# 1972 Corvette: Service News: Front Fender Skirt Availability

**Subject:** Corvette Service Fender Skirt

**Model and Year:** 1972 Corvette

**Date:** September 1974, Volume 46, Issue #9

Fig. 2—Corvette Fender Rework

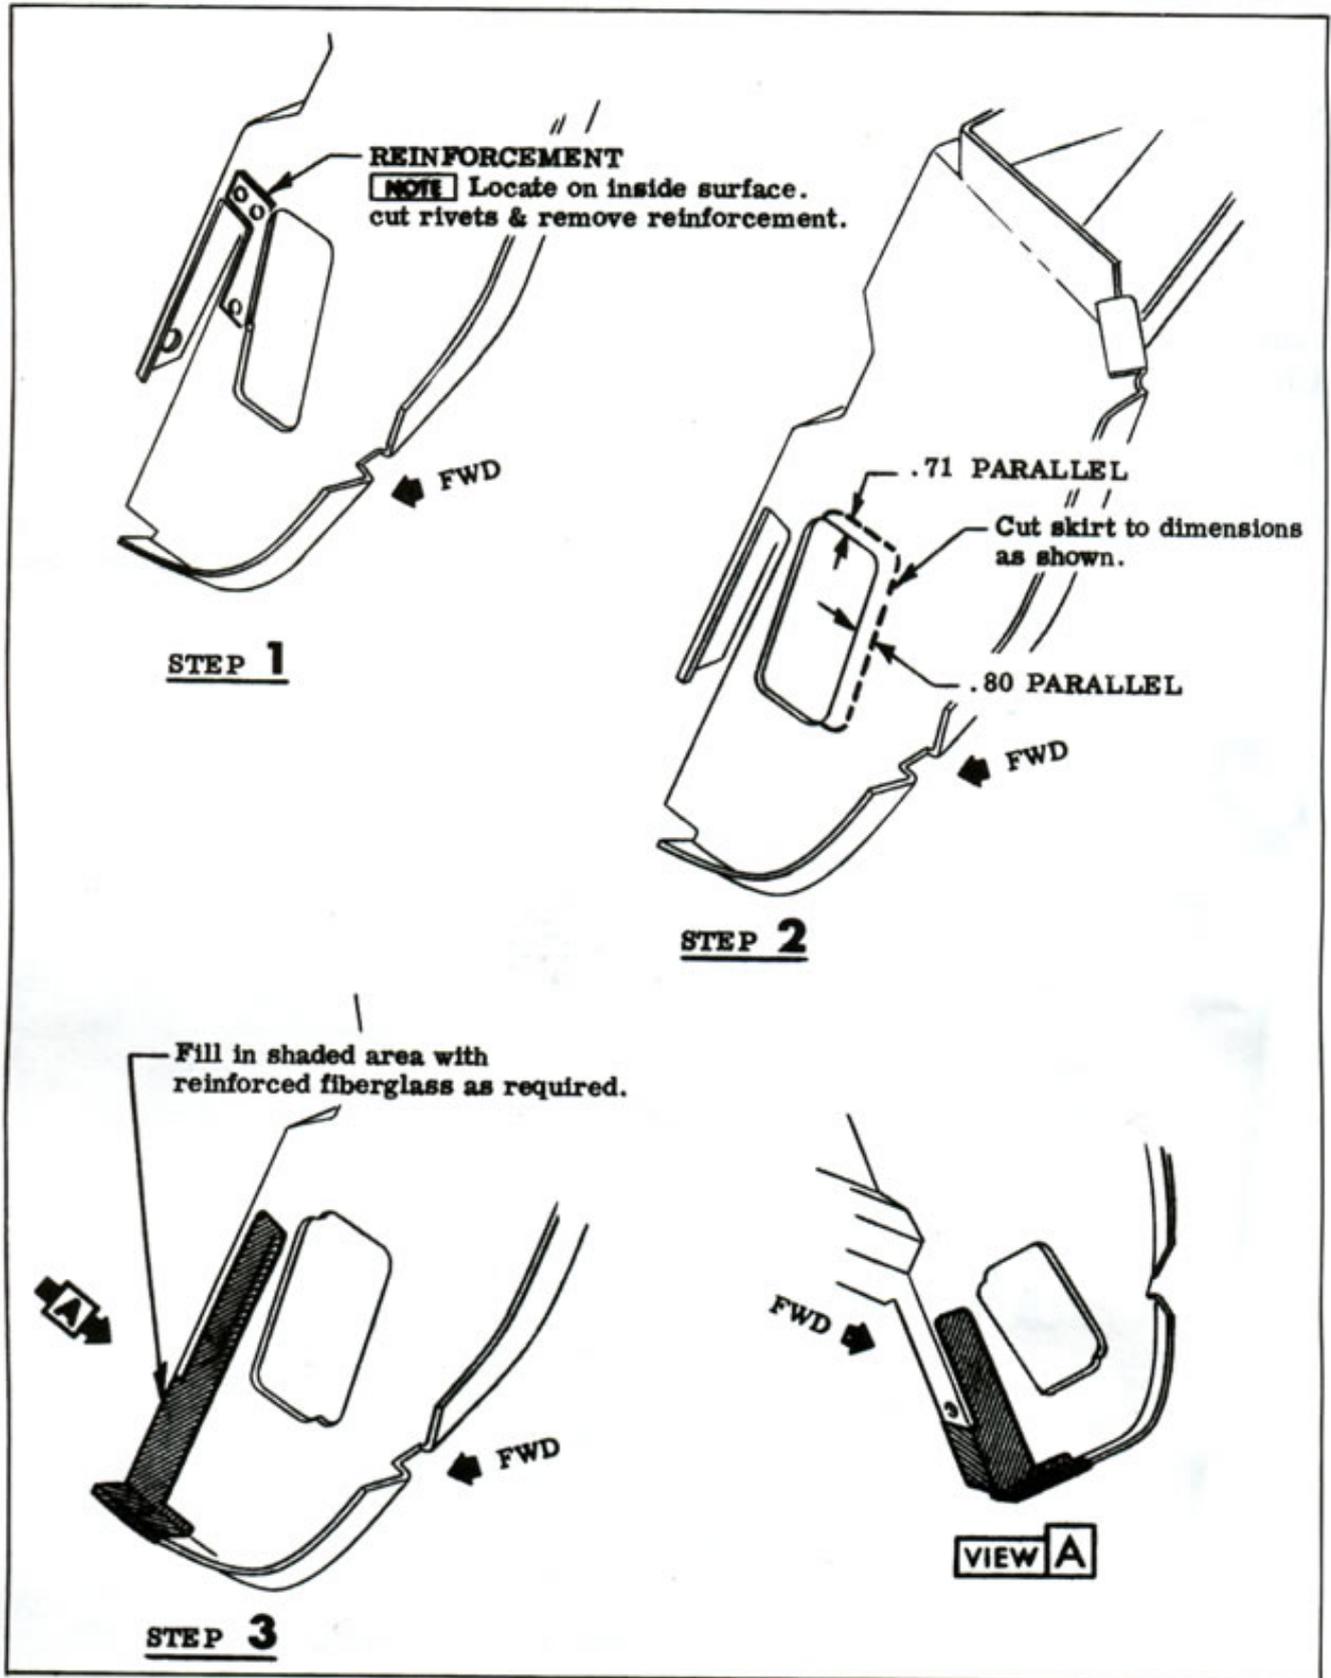
The 1972 Corvette Front Fender Skirts 6263509 L.H. and 3953054 R.H. are being cancelled and will be serviced by the 1973 Fender Skirts 331857 L.H. and 331858 R.H. This is being done because the tools have been reworked to make the 1973 skirt.

When using the 1973 skirts in place of the 1972 skirts, it will be necessary to remove and the steel reinforcement part number 334747-8 and add a material patch to provide a mounting surface for the radiator lower grille. See Fig. 2 for additional information.
